SOUTHERN PARKLANDS M12 CORRIDOR REVIEW

Submission to RMS

For: Western Sydney Parklands Trust

Date: 18.11.2019

Figure 13
Northern Parklands Cycleway Connections

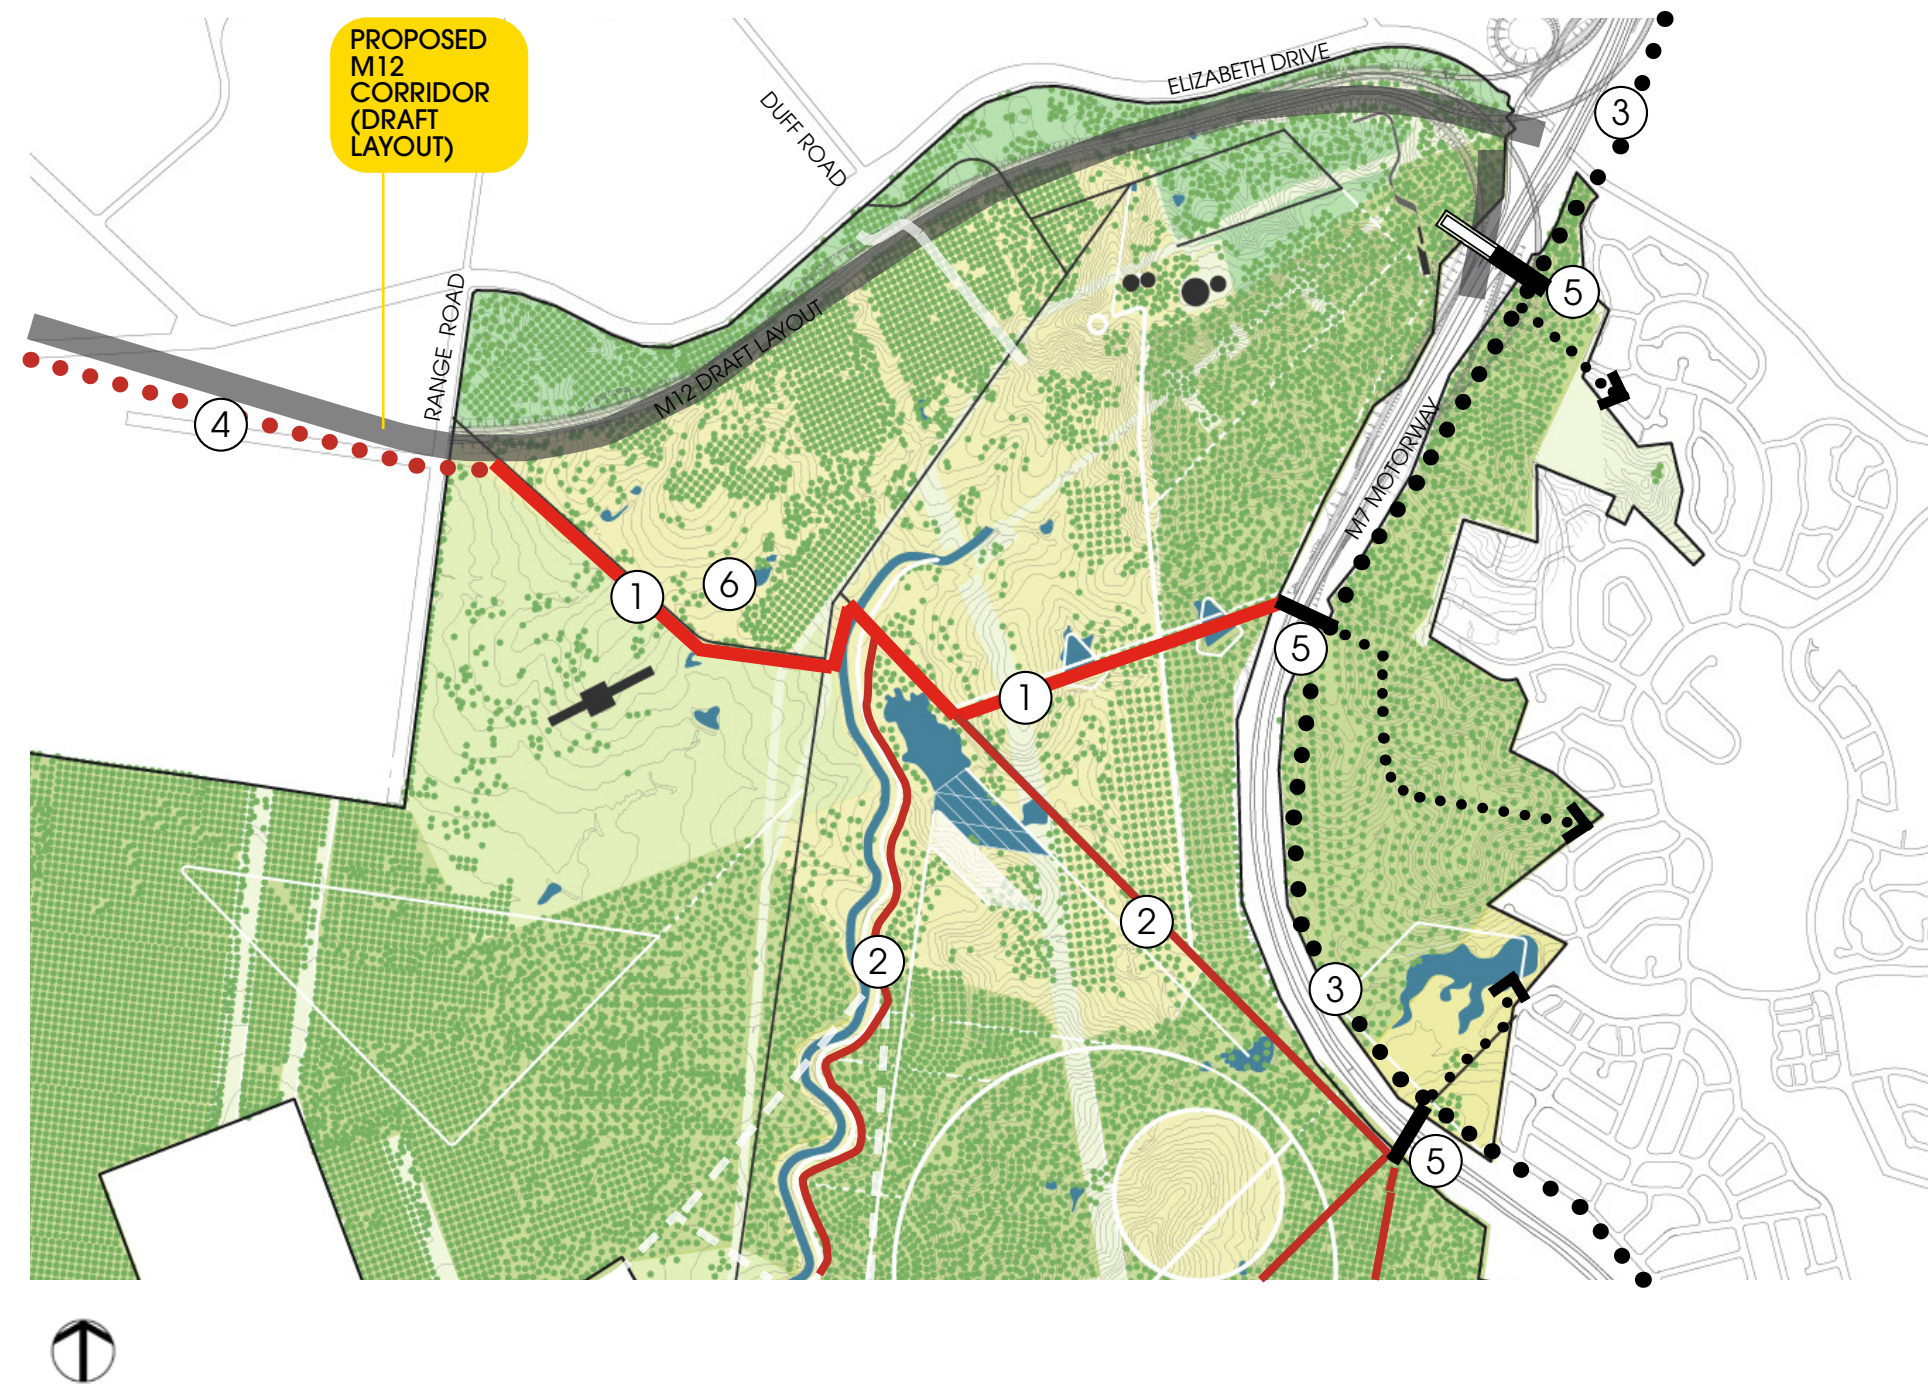
RMS requested that the Trust review the potential opportunity to accommodate a shared path linking the M12 to the M7 through the Parklands.

The options provided by RMS did not align with the future master planning for the precinct, and was therefore determined to not be a suitable option. The Trust has developed a potential suitable alignment for consideration.

The proposed main link through the Southern Parklands would accommodate the regional shared path function. This shared path connects the M7 to the proposed M12 shared path.

If the RMS does not wish to pursue this alignment then it is recommended that the cycle link be provided next to the M12 within the proposed road corridor.
